CITY OF CARMEL-BY-THE-SEA HISTORIC RESOURCES BOARD AGENDA

Regular Meeting Monday, November 17, 2025

- 3) **DS 25240 (Ramos):** Consideration of a Determination of Consistency with the Secretary of the Interior's Standards for Design Study application, DS 25240 (Ramos), for after-the-fact revisions to a previous approval (DS 23396) including the removal of horizontal wood siding, wood shingle siding, wood windows, and a Carmel stone chimney, replaced with new, and associated site and landscaping improvements at the historic "Rockwell House" located on the northeast corner of San Antonio and 12th Avenues in the Single-Family Residential (R-1) District

TO: Historic Resources Board Members
SUBMITTED Jacob Olander, Assistant Planner
BY:
SUBJECT: **DS 25240 (Ramos):** Consideration of a Determination of Consistency with the Secretary of the Interior's Standards for Design Study application, DS 25240 (Ramos), for after-the-fact revisions to a previous approval (DS 23396) including the removal of horizontal wood siding, wood shingle siding, wood windows, and a Carmel stone chimney, replaced with new, and associated site and landscaping improvements at the historic "Rockwell House" locat

WEST ELEVATION

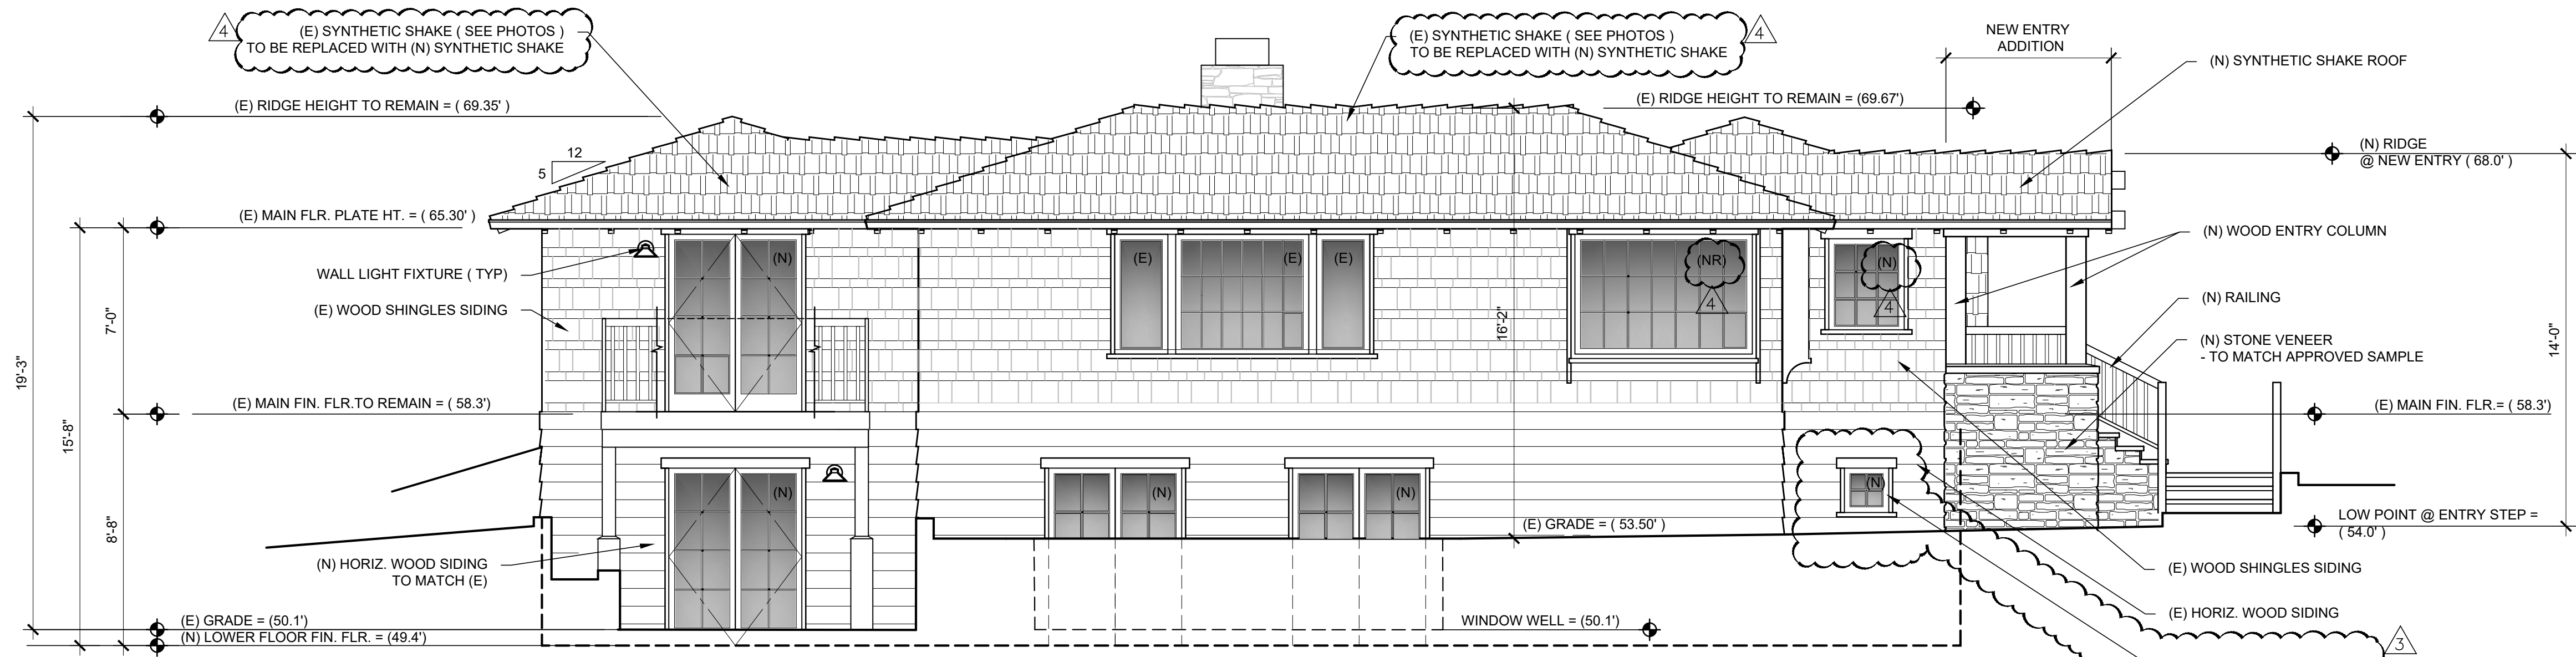
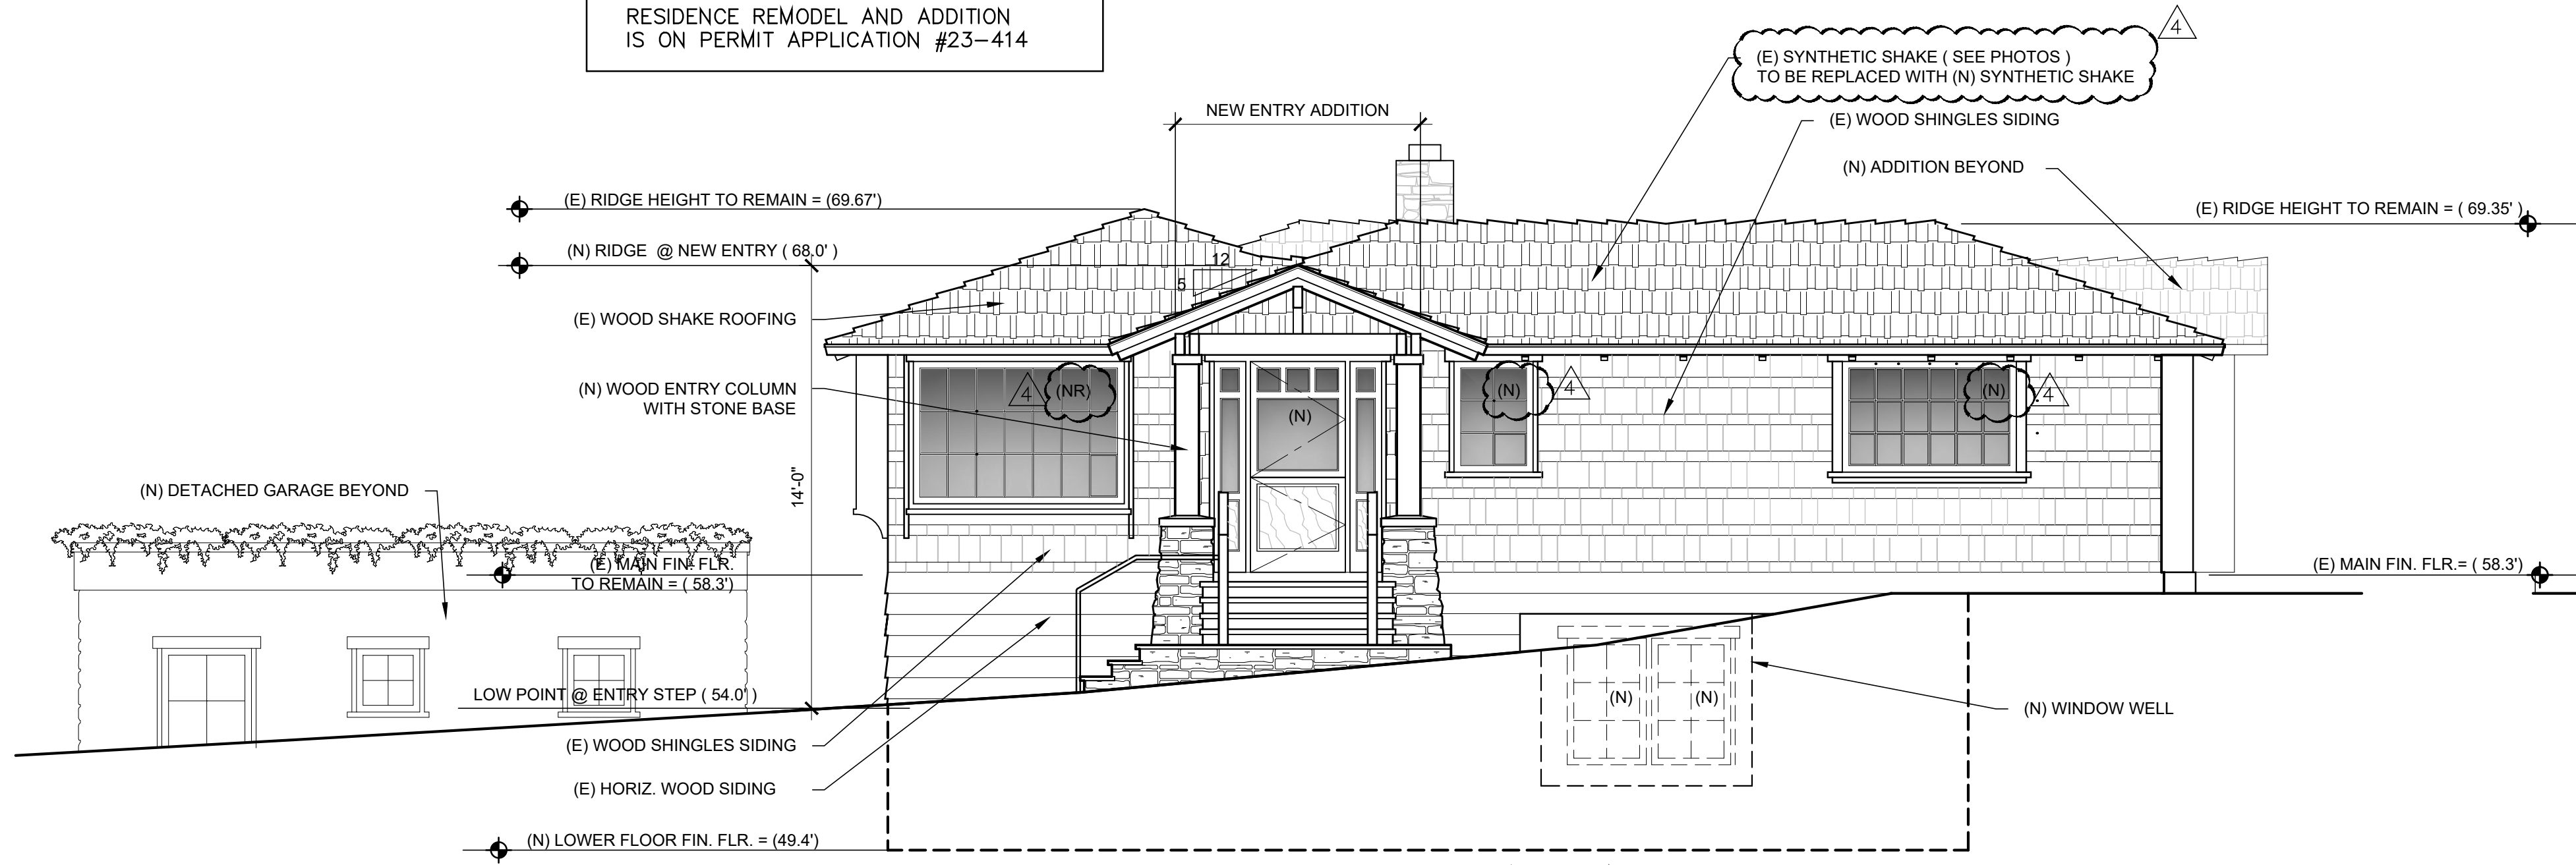
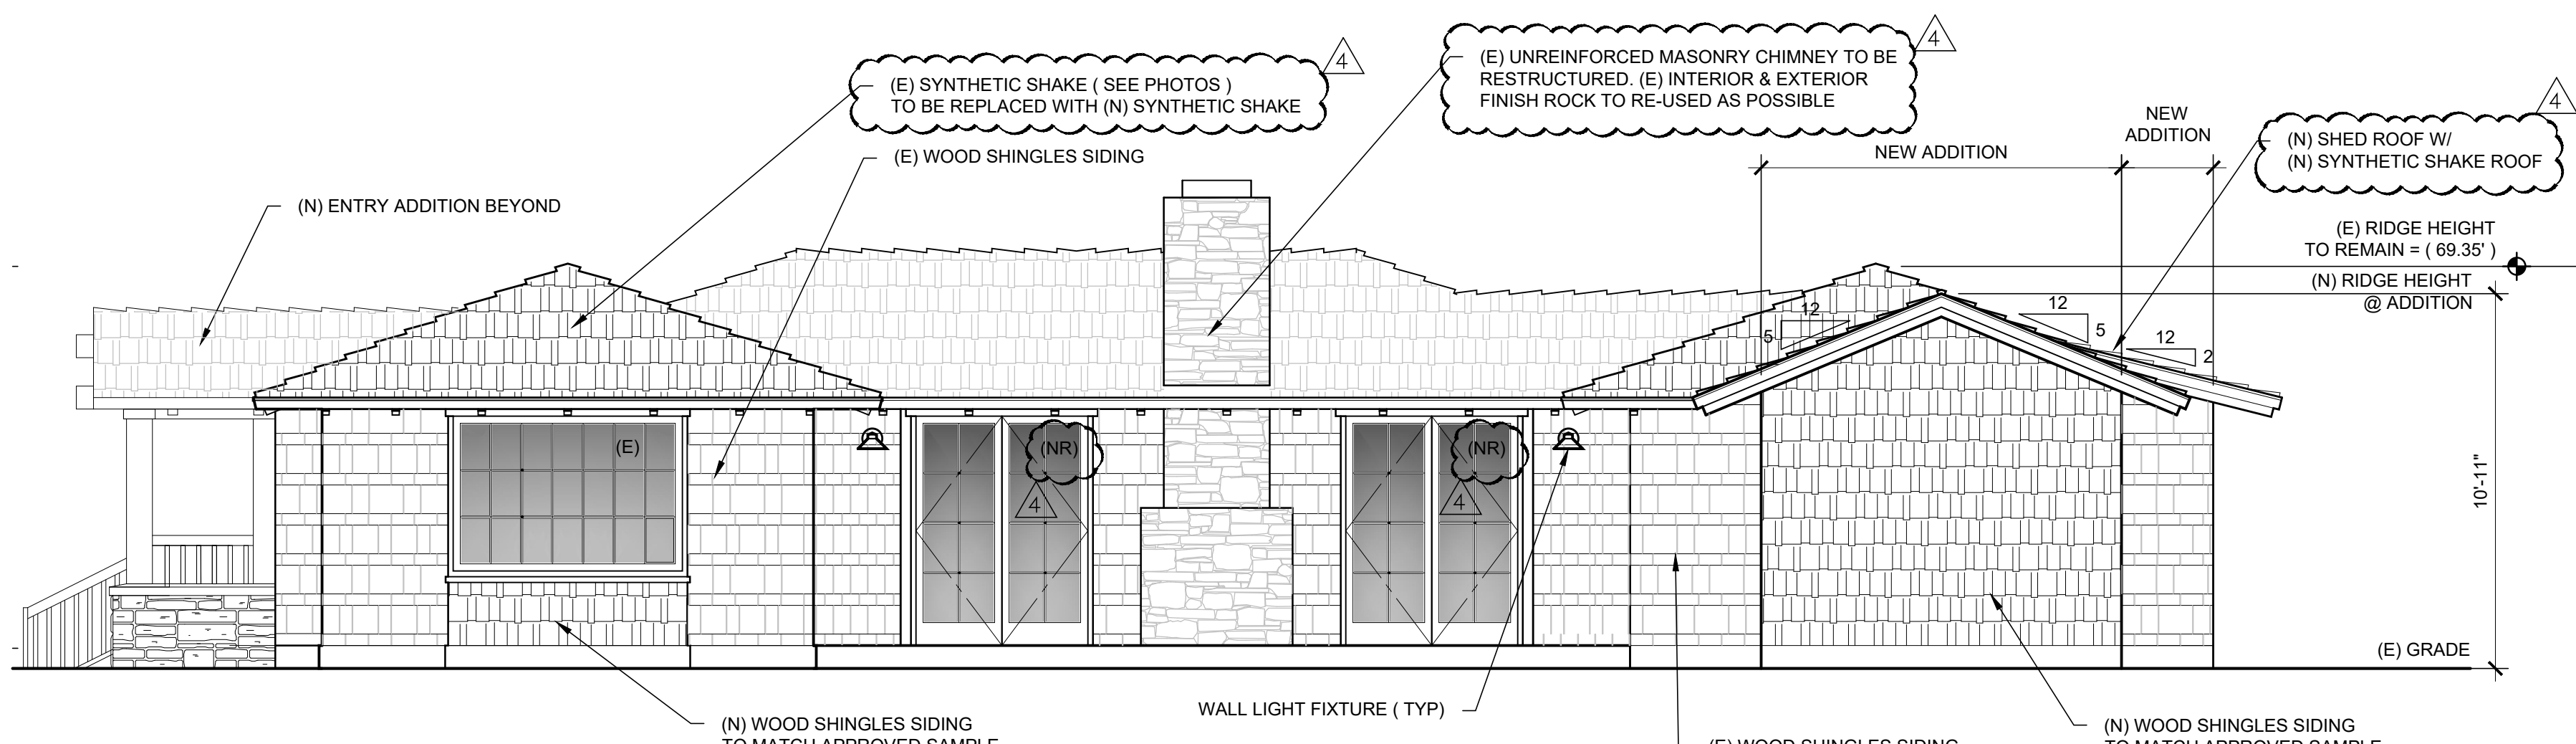
- Removal of horizontal wood siding (indicated on original plans to remain) with new in-kind horizontal wood siding.
- Installation of non-differentiated wood shingle siding on additions (conditioned under the original approval to be differentiated).

shingle siding on the new additions. To be consistent with Standard Nine, any new siding used in the additions should be differentiated from the existing siding, so the additions are clearly discernable from the historic house (replacement siding on the original house should match in kind, but siding on any additions should be differentiated). However, the shingles installed on the additions match the original “ribbon course” shingle pattern of the historic house (see Figure 6 in the Phase II Addendum). To differentiate the shingles on the additions, the architect and contractor have suggested removing 5/8” from selected shingles along the shingle course to create a staggered pattern (see Plan Sheet A3.1, Attachment 6). This solution will differentiate the new additions and meet the requirements of Standard Nine.

To be consistent with Standard Nine, any new siding used in the additions should be differentiated from the existing siding, so the additions are clearly discernable from the historic house. However, the shingles on the additions currently match the original "ribbon course" pattern used in the historic house (see Figure 6).³ To differentiate the shingles on the additions, the architect and contractor have suggested removing 5/8" from selected shingles along the shingle course in the additions to create a staggered pattern (see Plan Sheet A3.1). This solution will differentiate the old from the new materials and meet the requirements of Standard Nine.

NOTE:
RELOCATED OR EXISTING WINDOWS (NR)
AS ORIGINALLY INDICATED, REPLACED
WITH "LIKE-TO-LIKE".

G:\shortcuts\targets-by-id\11103a\09\06\04\02\0204-17_L-1.0 Const.dwg 10/31/2025

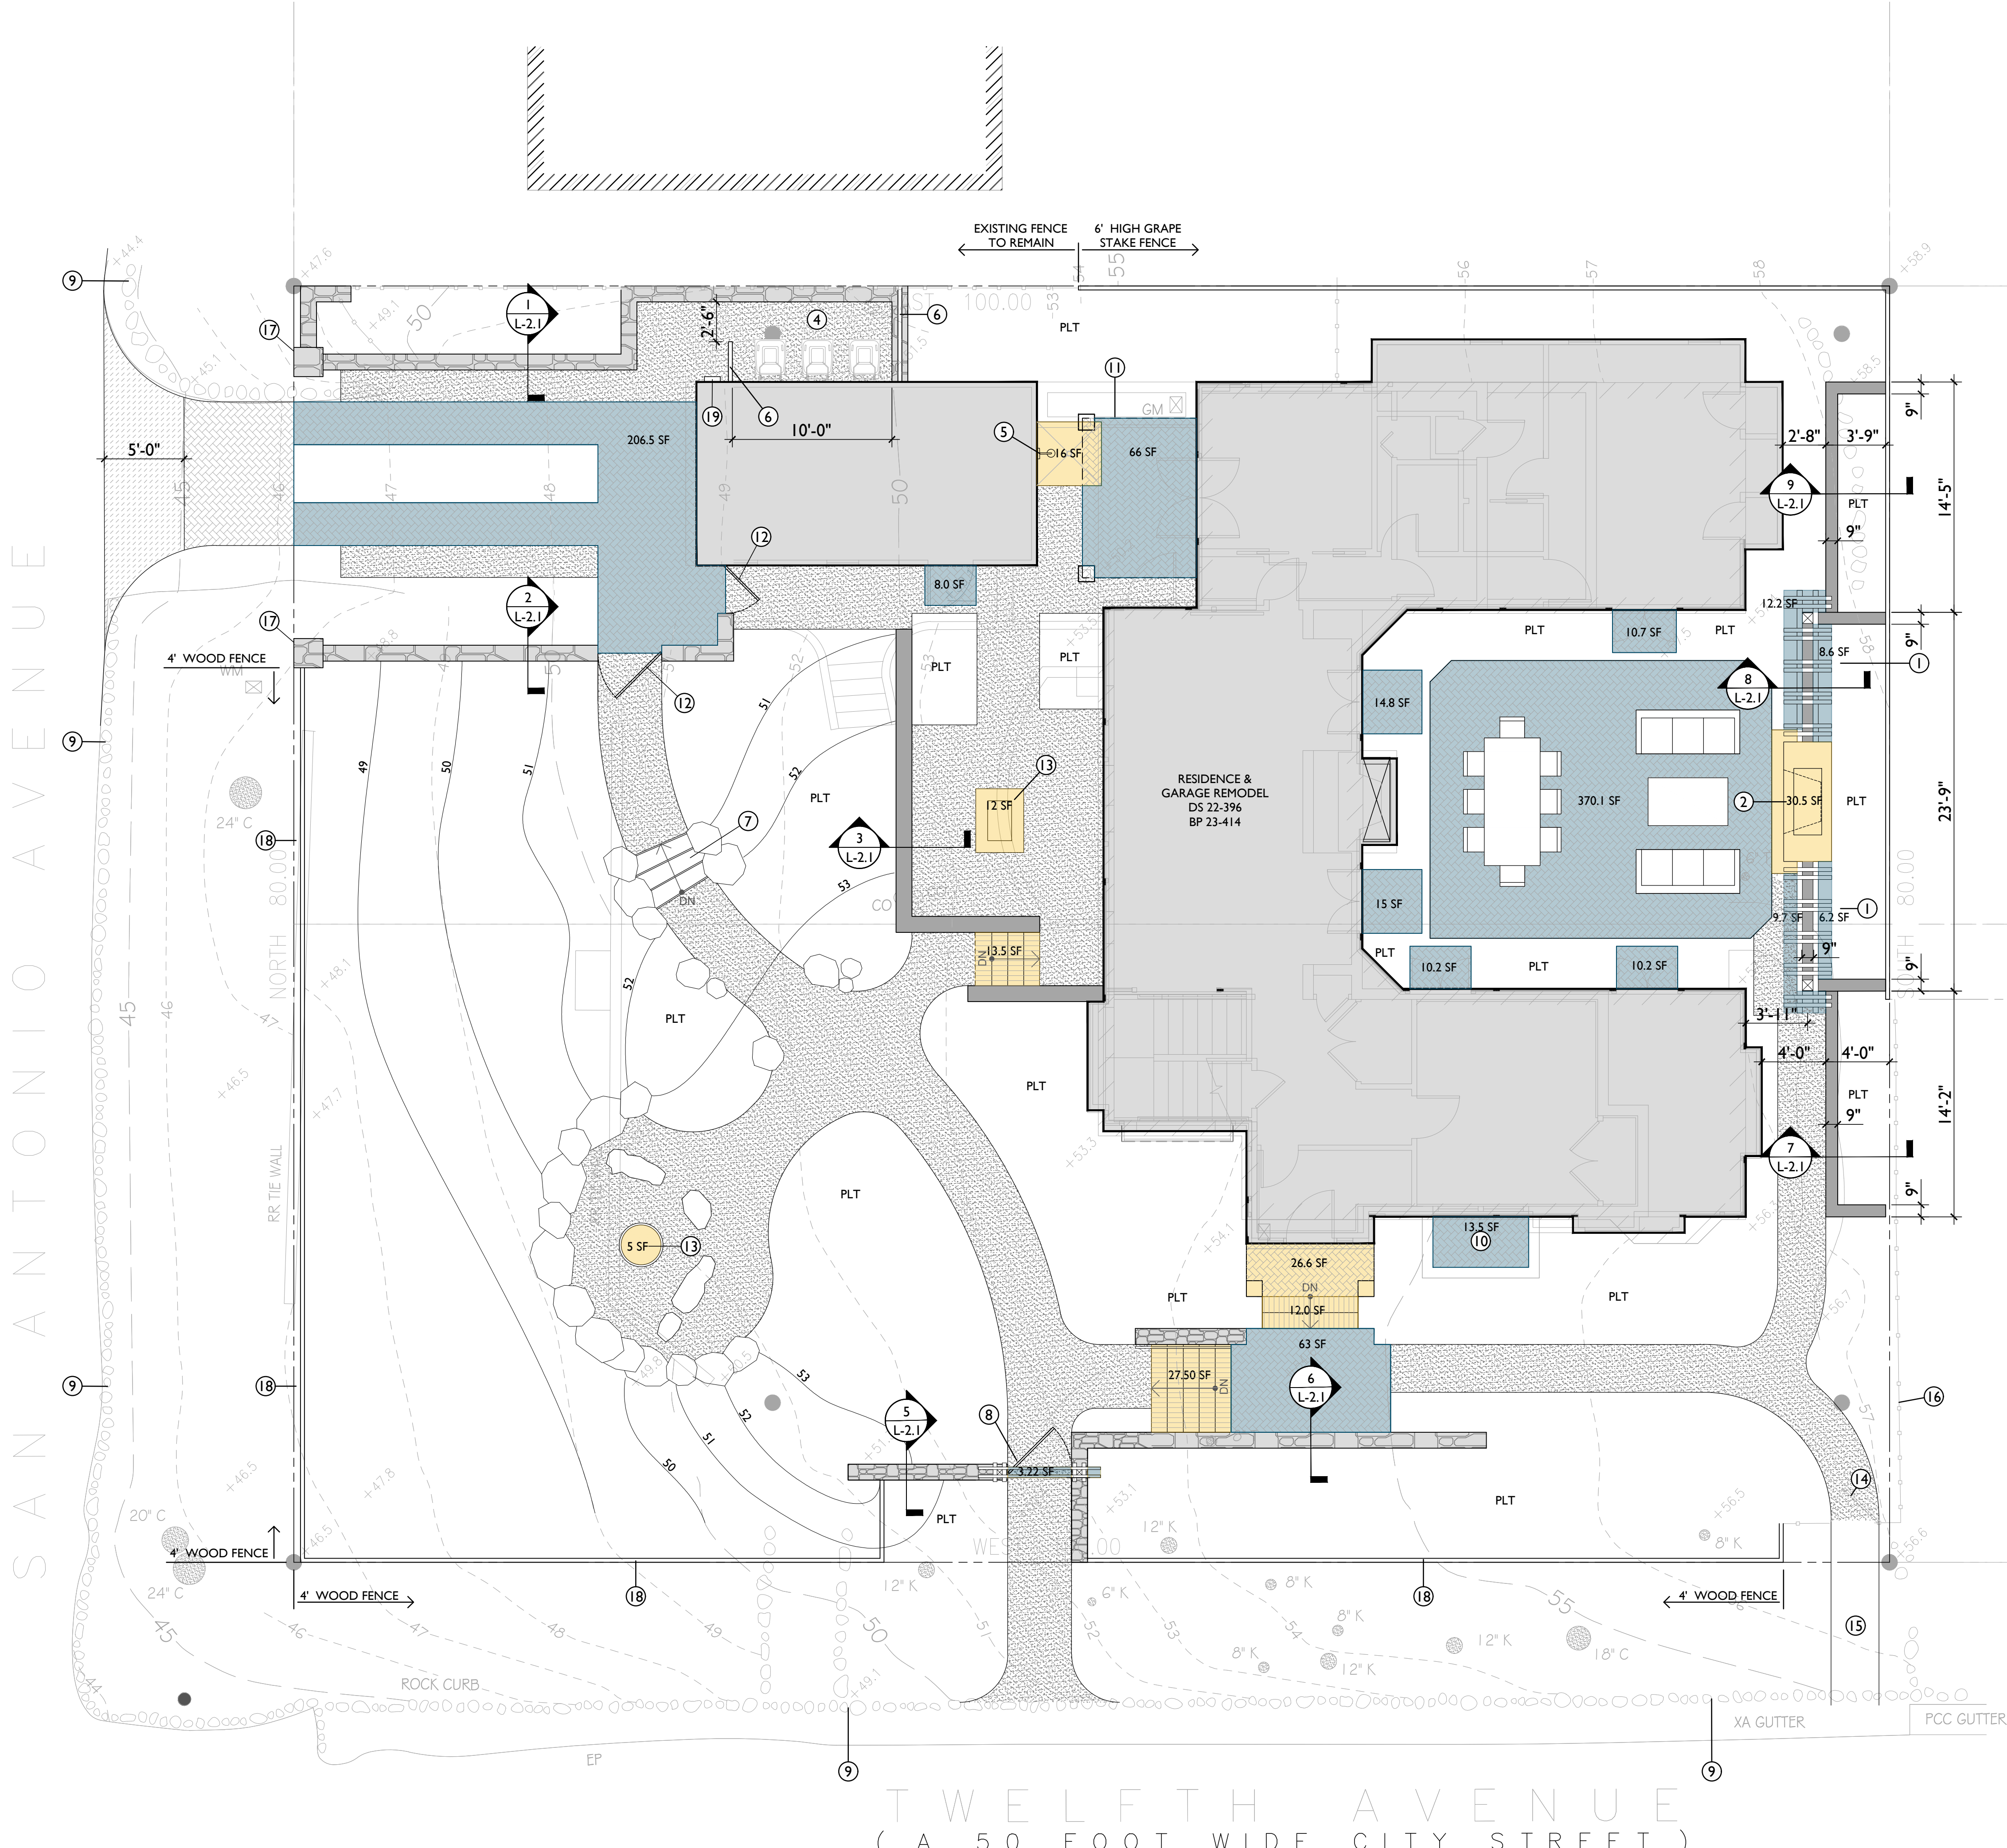
without affecting the essential form and integrity of the property. It is recommended that no retaining walls, as shown in Plan Sheet L-1.0, should abut the walls of the historic house. One retaining wall abuts the house next to the new entry and the other extends west from the west elevation as part of the seating area enclosure. A small gap (1"-6") should separate the retaining walls from the house to ensure its integrity.

Staff Analysis. Staff concurs with Ms. Clovis's assessment of the project. Staff has included a note in the Determination of Consistency recommendation below that the determination will not be made without updated plans prior to staff approval of the project such that no retaining walls will abut the residence.
